**Lee Nuclear Station Units 1 and 2  
Description, Scope of Changes, and FSAR Impacts due to Plant Relocation and  
Additional Design Enhancements**

**Description and Rationale for Lee Nuclear Station Units 1 and 2 Relocation and  
Additional Design Enhancements**

FIGURE 2.4.12-206

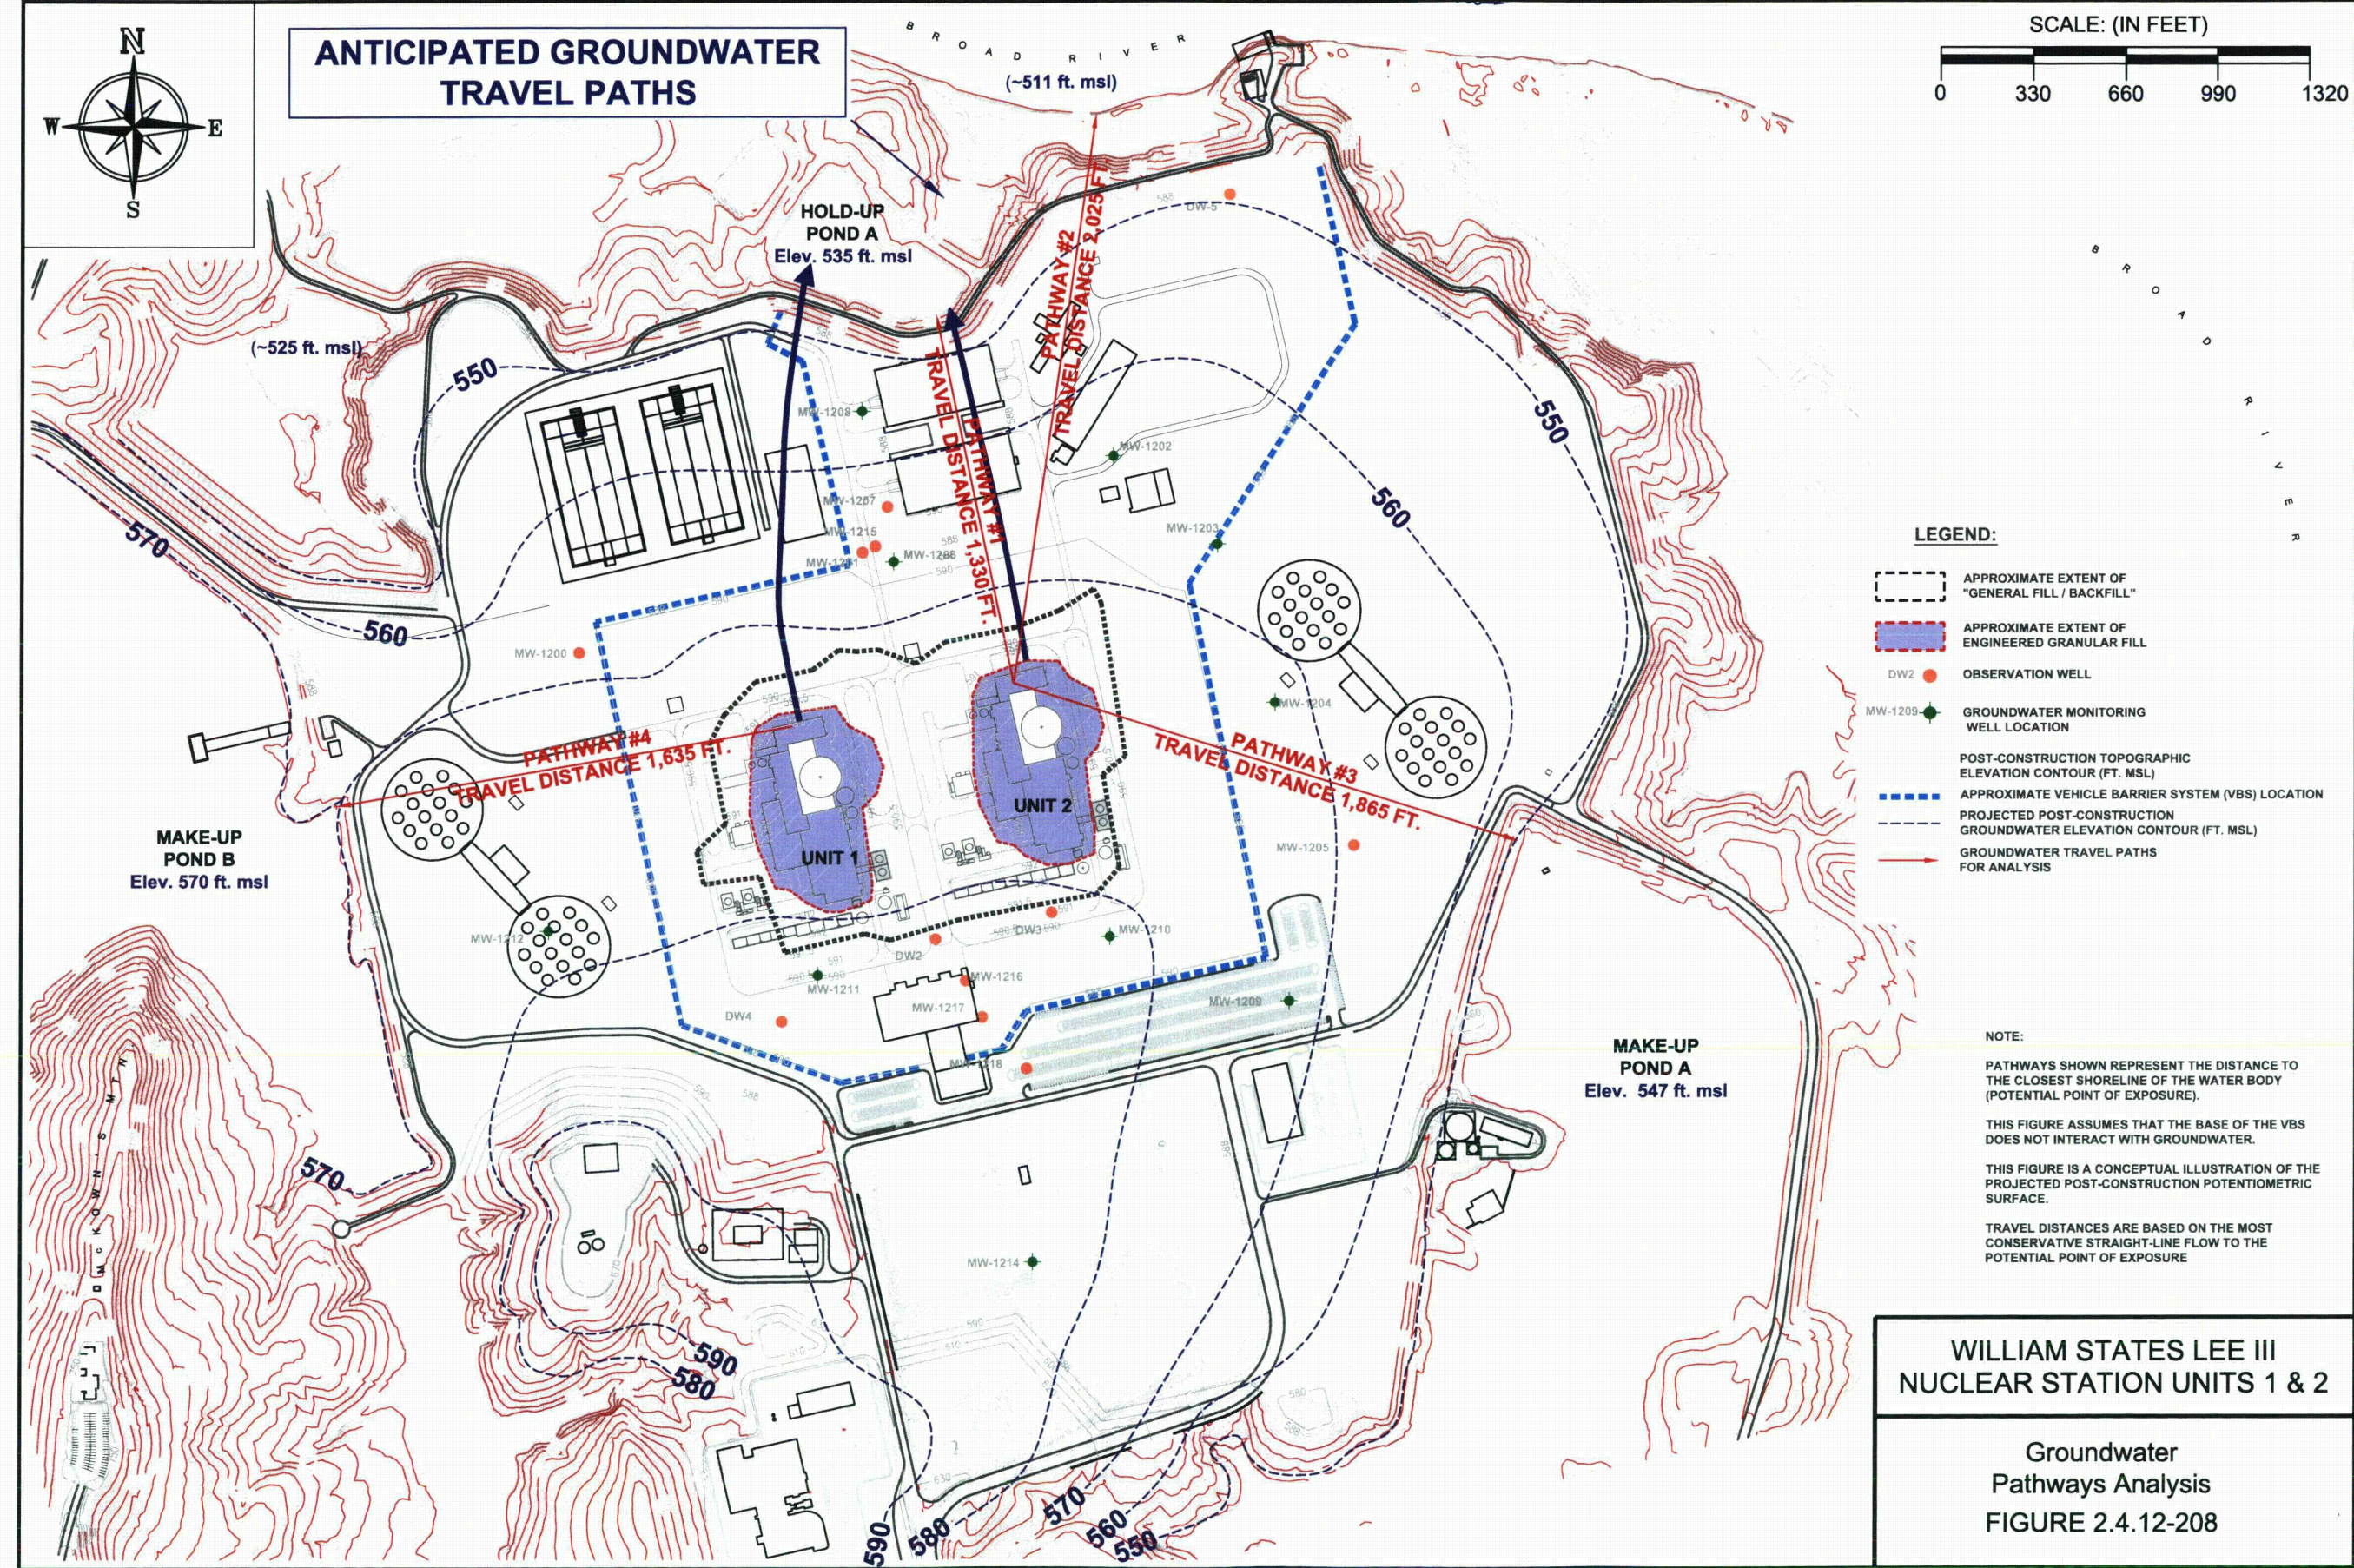
69. COLA Part 2, FSAR Chapter 2, Figure 2.4.12-206 is revised as follows:

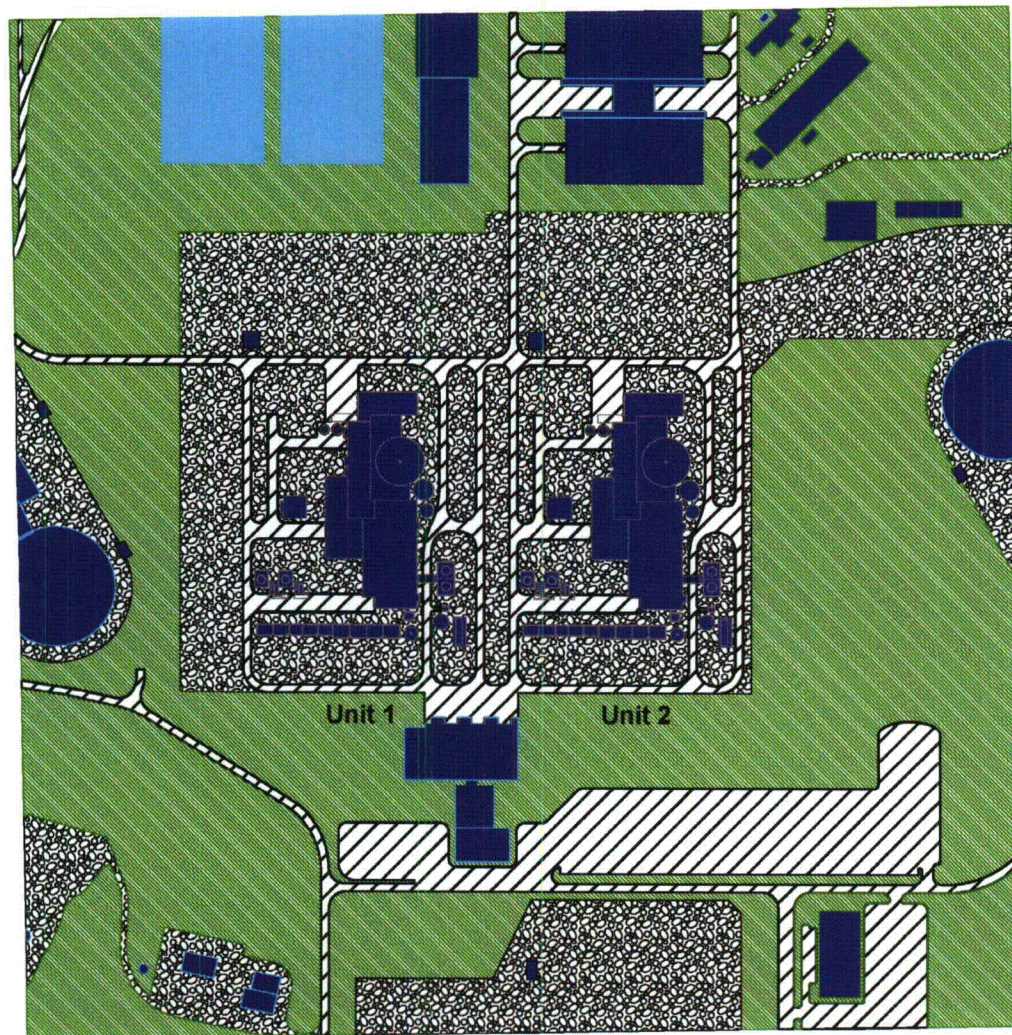
70. COLA Part 2, FSAR Chapter 2, Figure 2.4.12-208 is revised as follows:

FIGURE 2.4.12-209

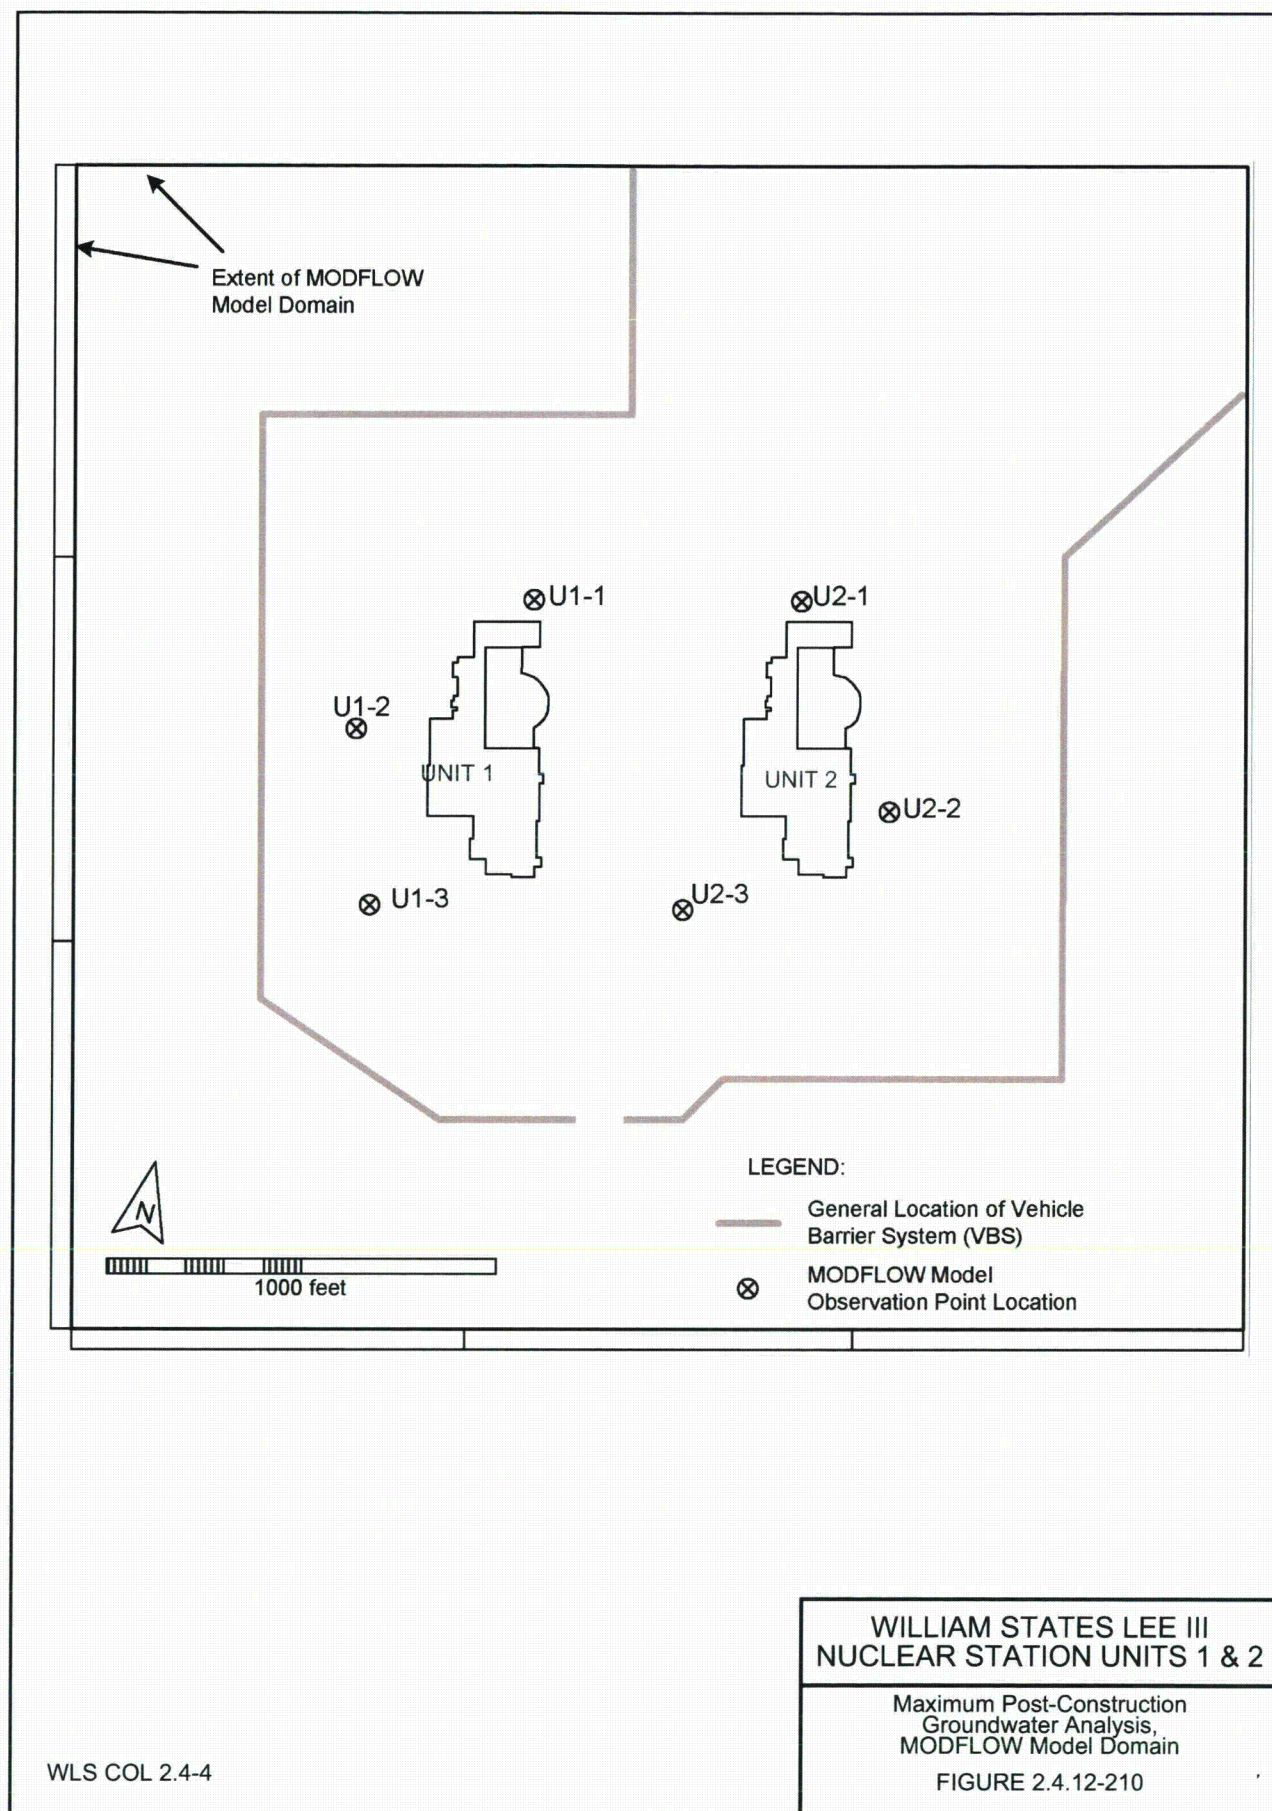
71. COLA Part 2, FSAR Chapter 2, Figure 2.4.12-209 is revised as follows:

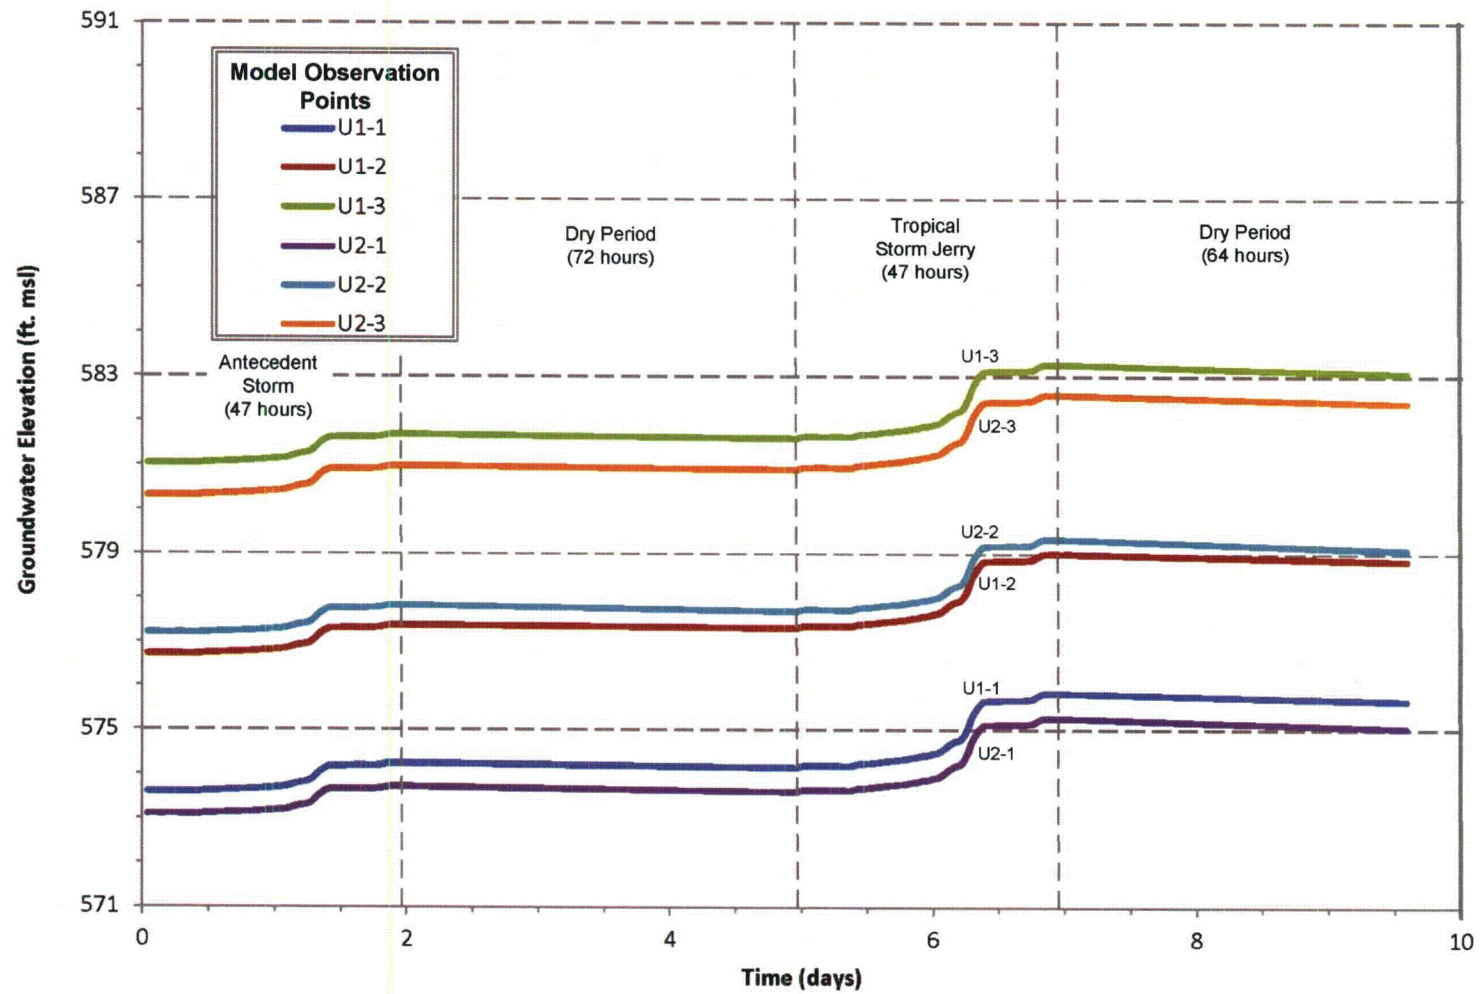
72. COLA Part 2, FSAR Chapter 2, Figure 2.4.12-210 is revised as follows:

**Figure 8.2-202**

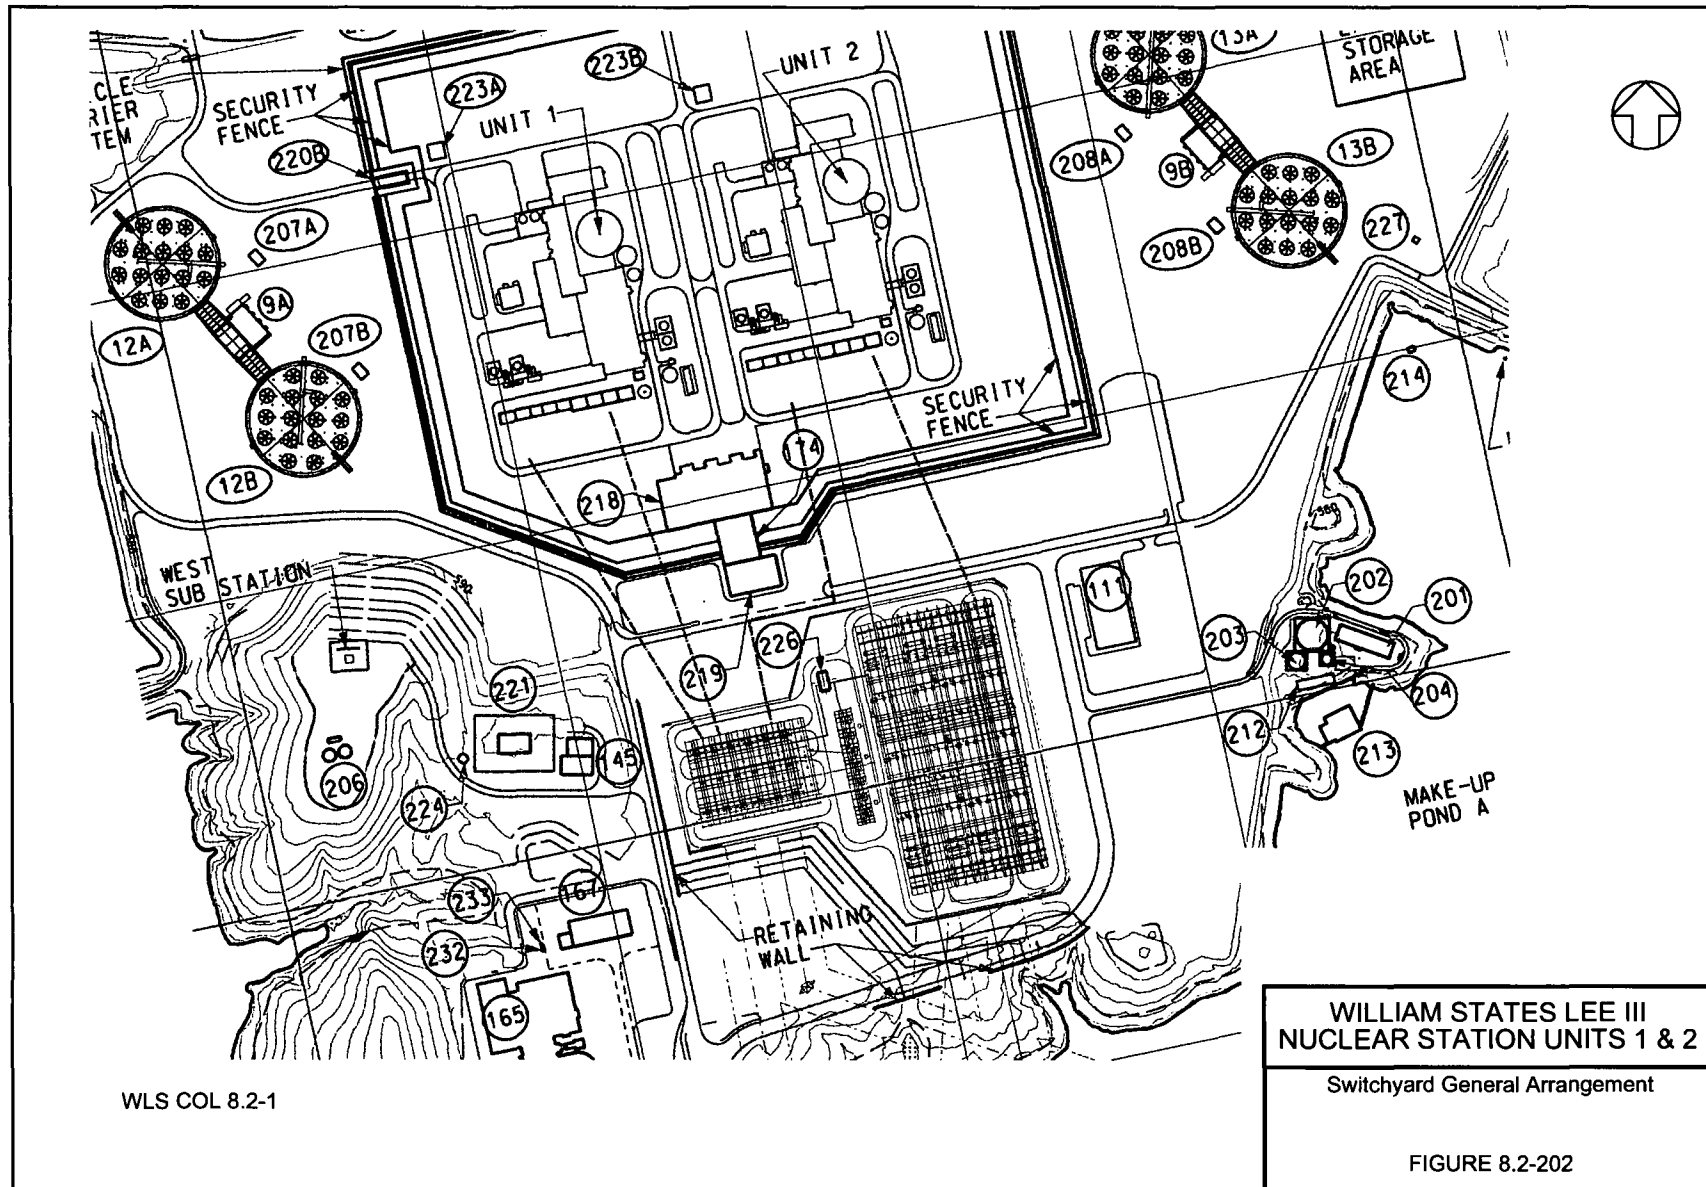
The information provided in FSAR Chapter 8 is limited to the incorporation by reference to the AP1000 DCD and programmatic information that is not dependent on the plant location. However, FSAR Figure 8.2-202 provides a layout depicting orientation of the 230 kV and 525 kV switchyards relative to Lee Units 1 and 2. This figure is revised to incorporate the updated locations of the units.

1. COLA Part 2, FSAR Chapter 8, Figure 8.2-202 is revised as follows:
